REGULATORY INFORMATION DISTRIBUTION SYSTEM (RIDS)

SUBJECT: Provides responses to questions posed by NRC during TVA/NRC
 940324 meeting in Rockville, MD re proposed approach to
 resolve vertical flexible floor issue at BNP.

**BELLEFONTE NUCLEAR PLANT (BLN) - RESPONSE TO NRC QUESTIONS ON
THE BLN VERTICAL FLEXIBLE FLOOR STUDY**

FIGURE 3.7.1-5

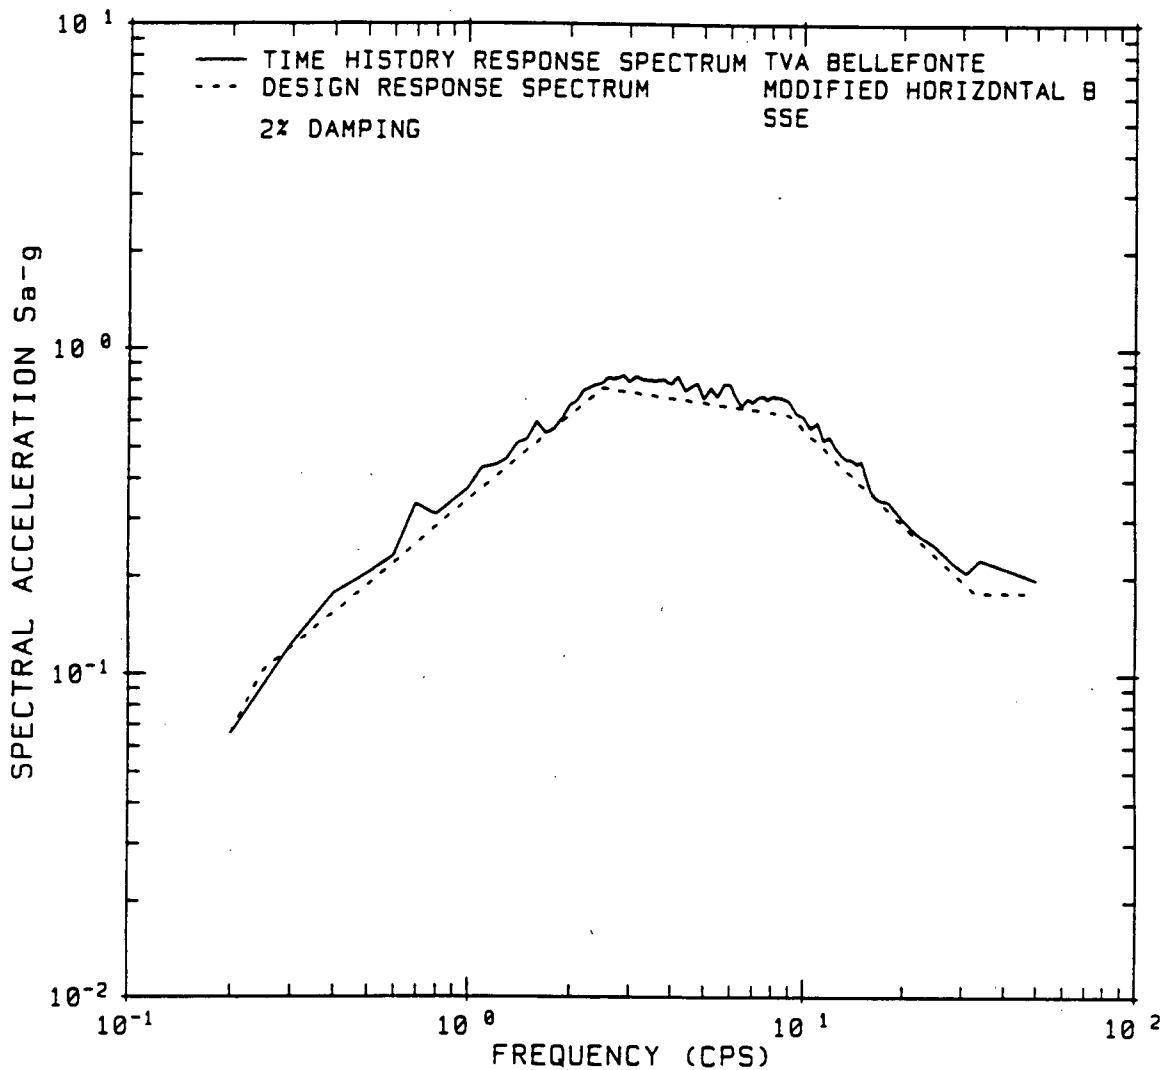
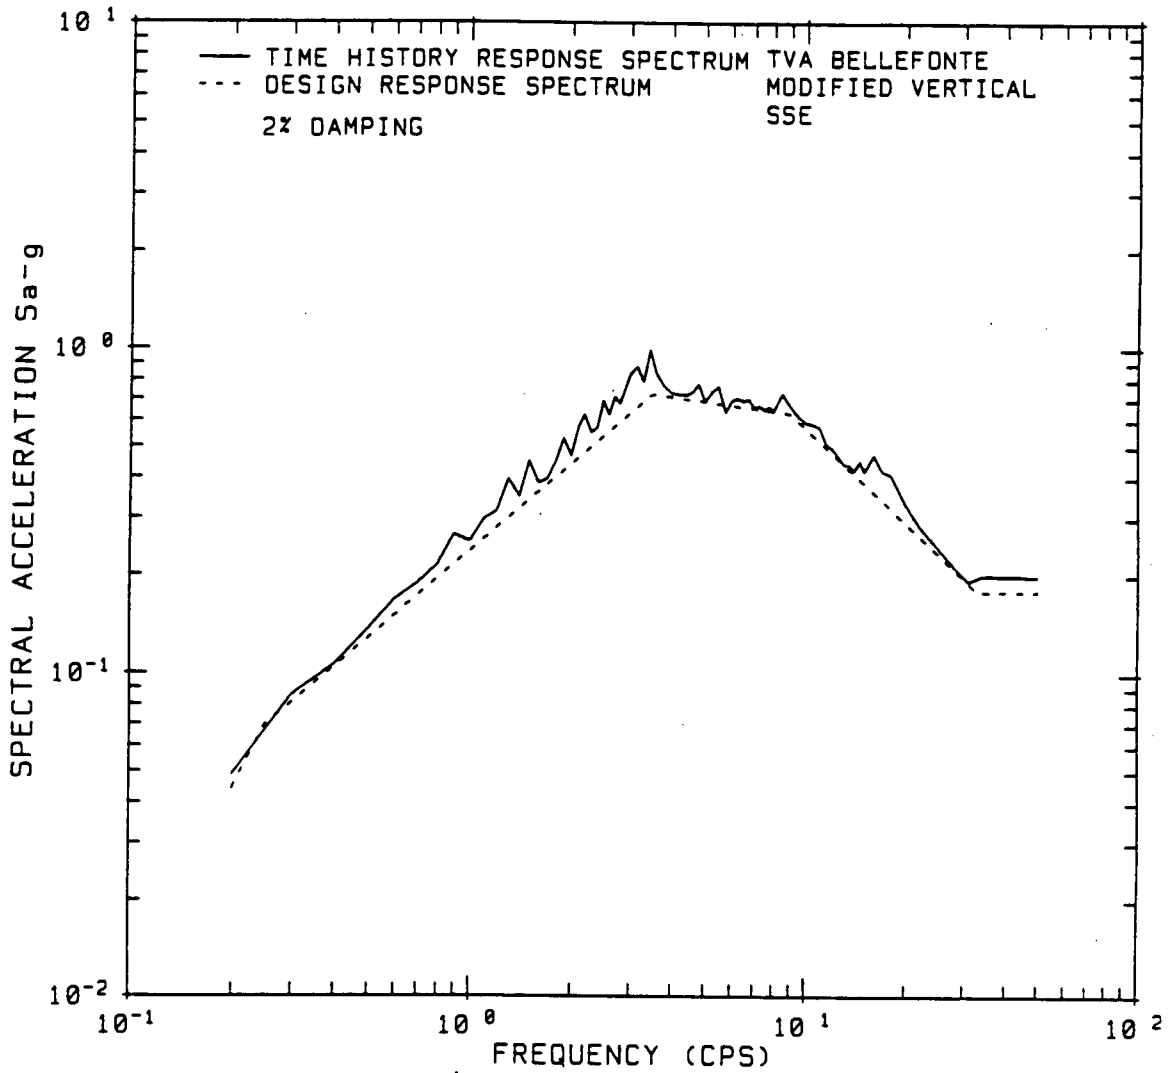
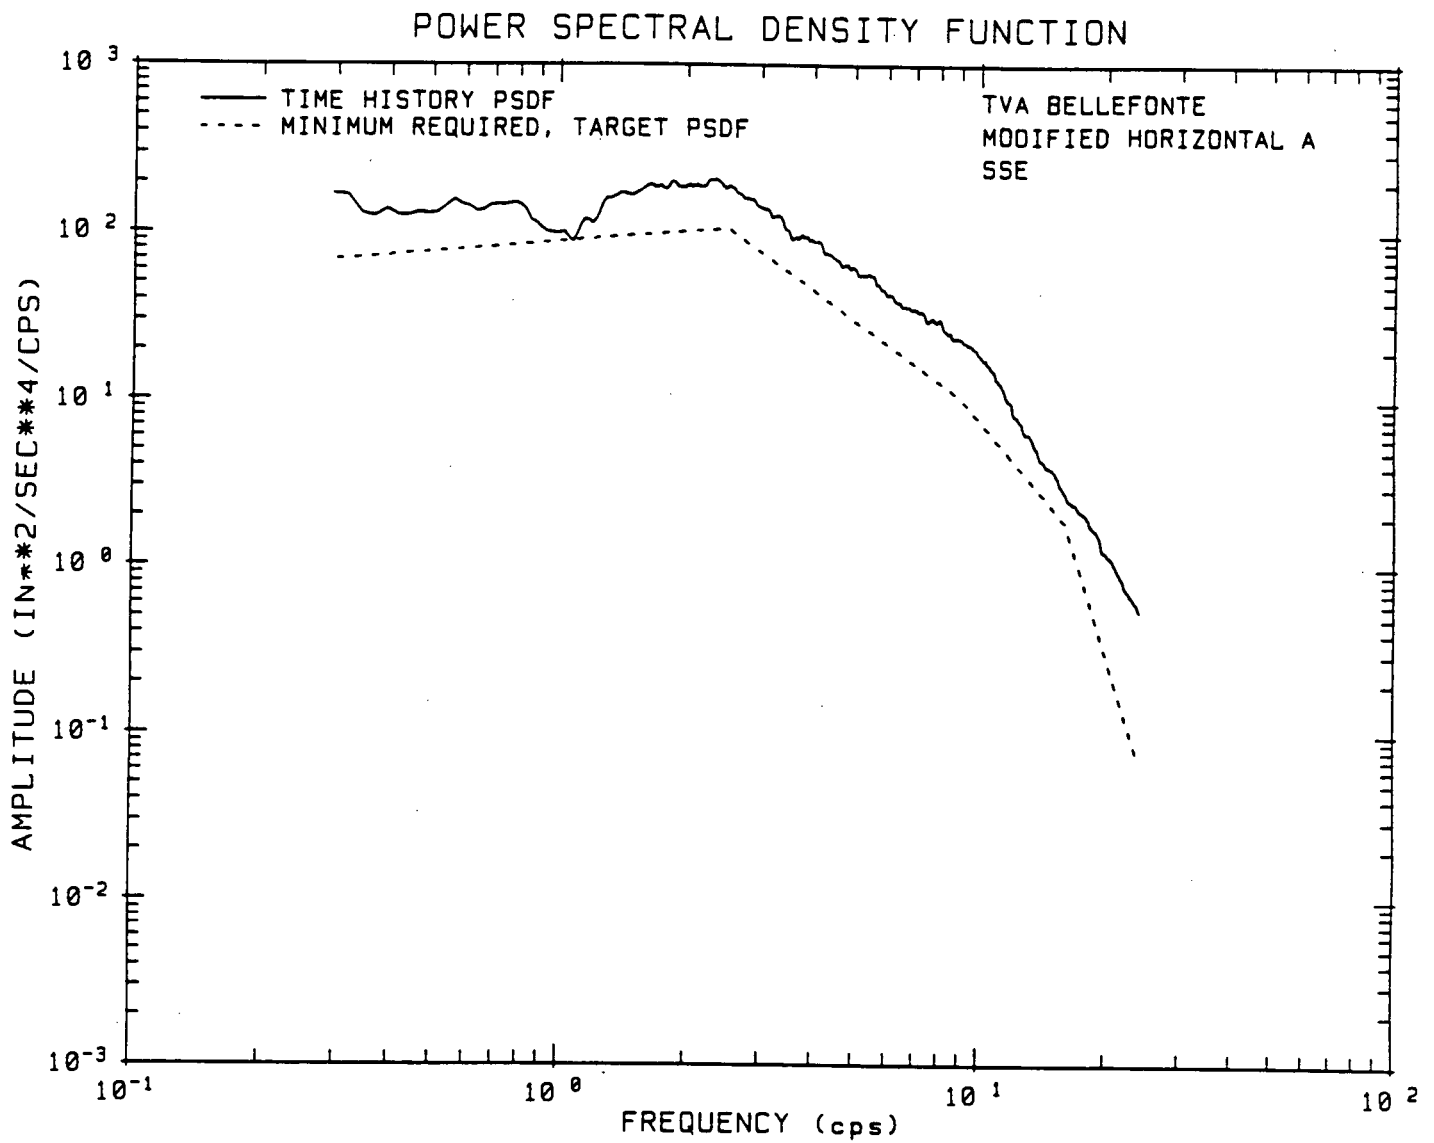
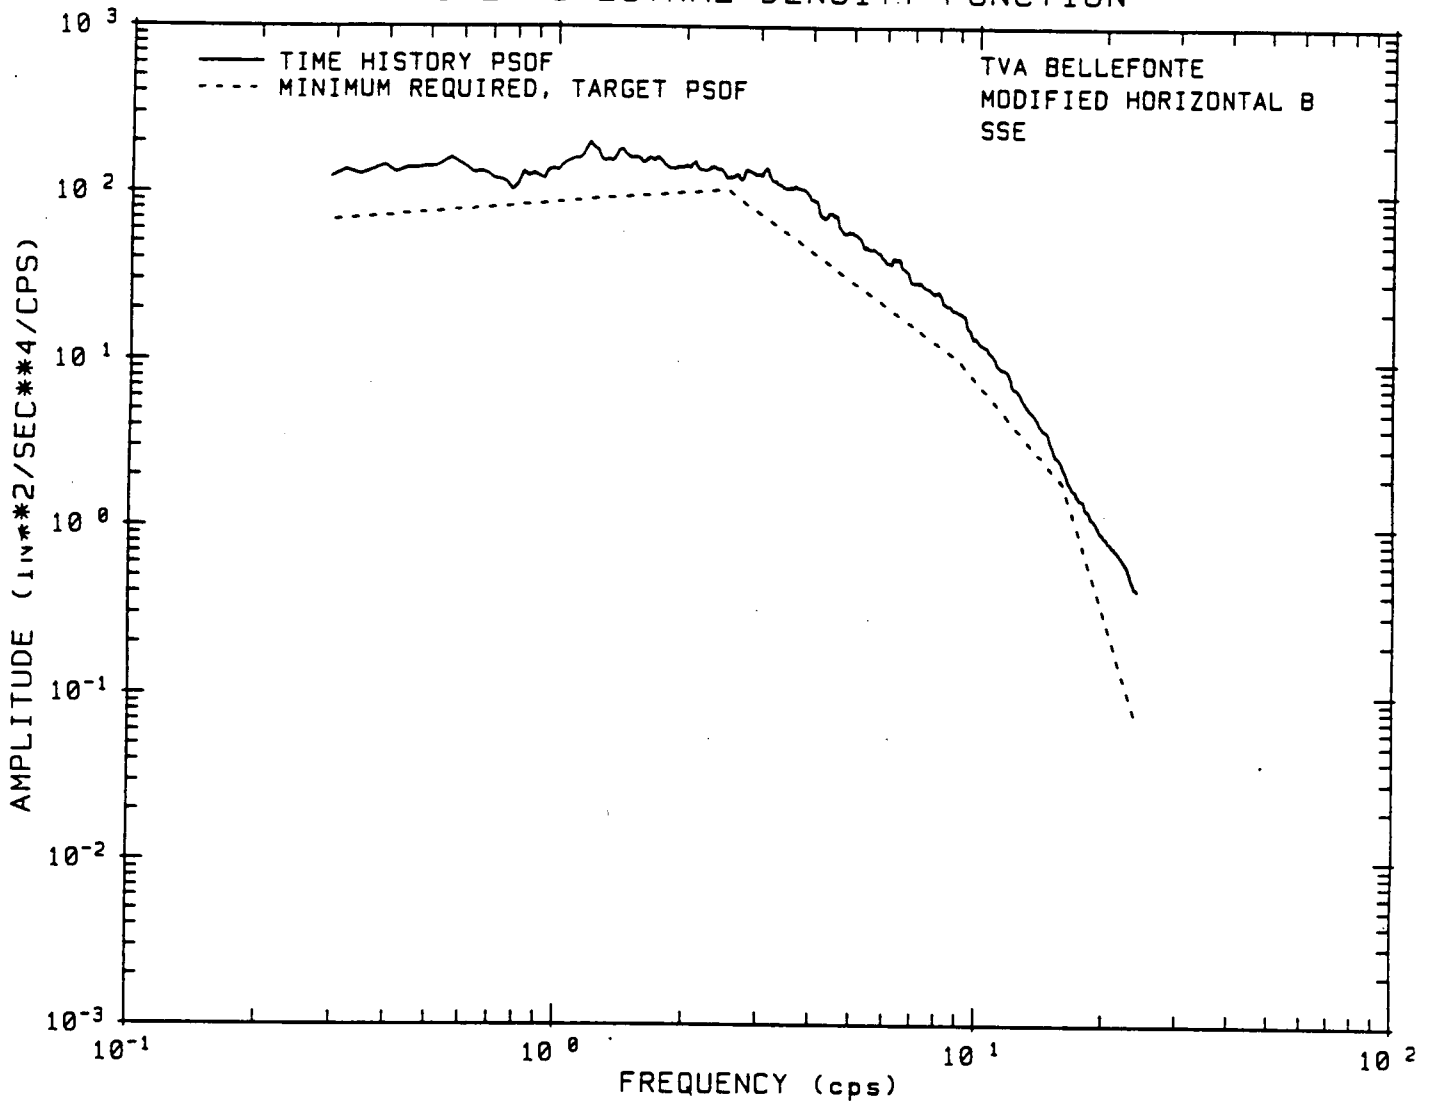
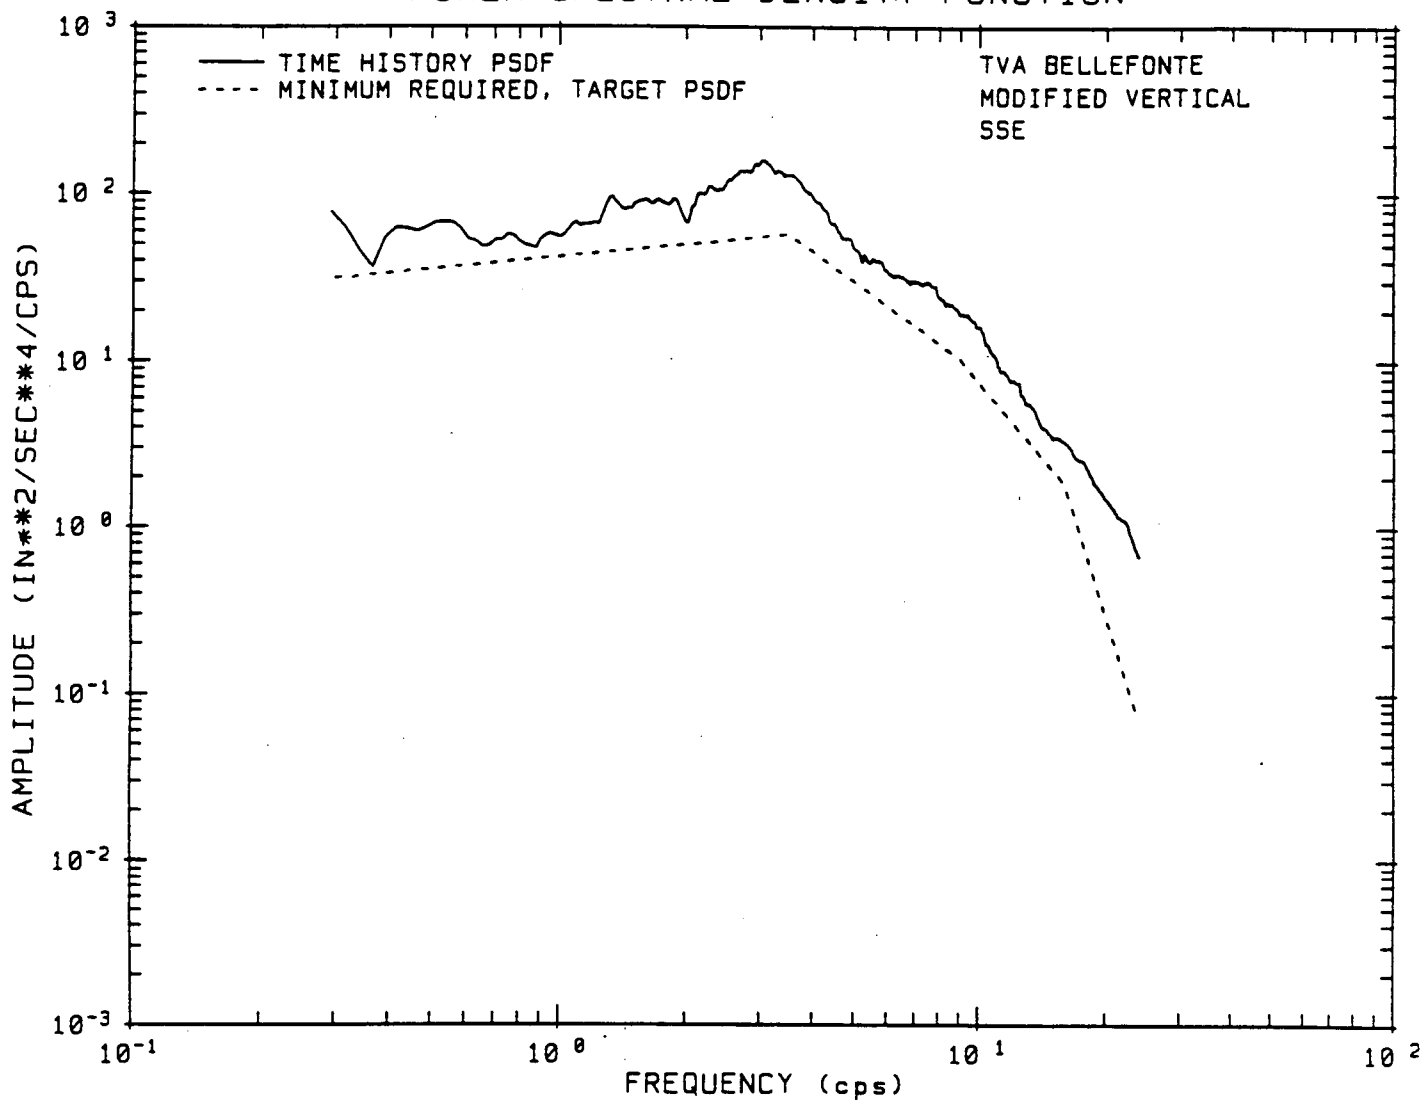
Provide plots of the power spectral density functions (PSDFs), for the BLN design basis SSE synthetic acceleration time-histories to verify they meet the Standard Review Plan (SRP) 3.7.1 target PSD enveloping guidance.

Discussion of the design basis ground response spectra (i.e., Regulatory Guide 1.60), development of the three synthetic time-histories, computation of the corresponding ground response spectra and power spectral density functions (PSDFs), and meeting of SRP 3.7.1 response spectra and PSD enveloping guidance is provided in Sections 3.7.1.1 and 3.7.1.2 of the BLN FSAR (Amendment 30). Plots of the synthetic time-histories, design response spectra, and PSDFs are provided in FSAR Figures 3.7.1-1 through 3.7.1.27. [See attached sheets for examples.]

Response Spectra Curve Comparison - Bellefonte Nuclear Plant

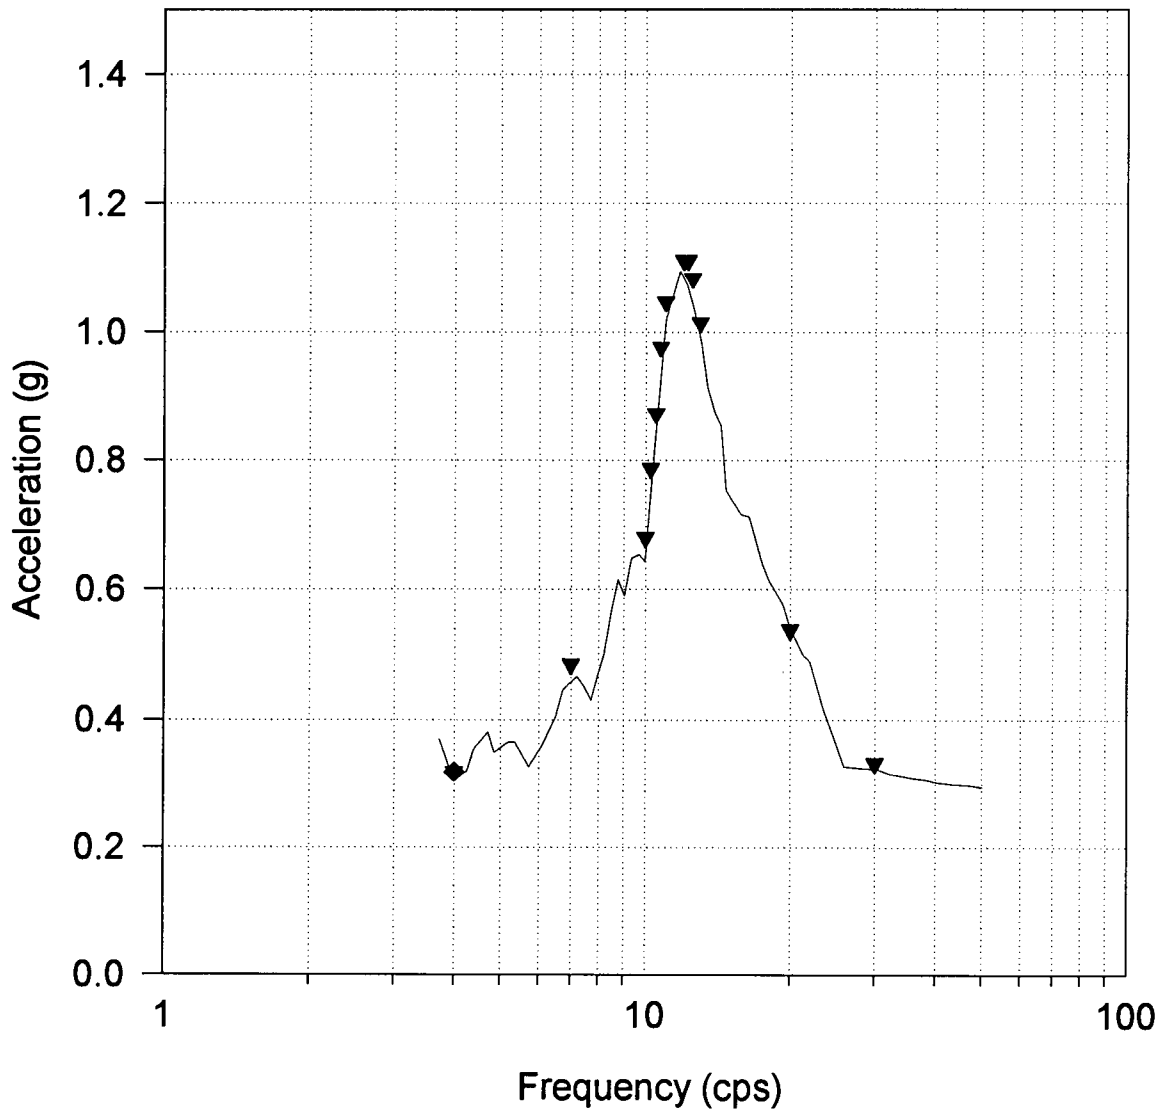
Provide verification that the equipment/component responses (i.e., flexible floor response spectra, FFRS) computed using the equipment-structure-interaction (ESI) methodology proposed by BLN are equivalent to the responses obtained using an equivalent time domain solution. In the time domain solution a SDOF oscillator representing the equipment/component is to be incorporated into the lumped mass building/flexible floor model by attaching it directly on the flexible floor mass.

An analysis was performed for auxiliary/control building upper elevation 685' which is representative of other floors. In this analysis SDOF oscillators representing the equipment/components were incorporated into the lumped mass building/flexible floor model of the Auxiliary-Control Building by attaching them directly to the flexible floor mass. The equivalent mass of the equipment/component SDOF oscillators was taken as 3% of the flexible floor SDOF oscillator. The individual equipment/component SDOF oscillator frequencies evaluated included 4.0, 7.0, 10.0, 10.25, 10.5, 10.75, 11.0, 12.0, 12.25, 12.5, 13.0, 20.0, and 30.0 Hz. The modified lumped mass building/flexible floor/equipment model was subjected to an input motion at its base corresponding to the BLN design basis OBE vertical artificial acceleration time history. A time domain dynamic response analysis was performed utilizing the STARDYNE computer code.

The results of this time domain solution was compared to that obtained using the methodology presented in the December 1993 report using the computer code FRIDAY; see the attached figure. Review of the figure demonstrates that both methodologies provide essentially identical results.
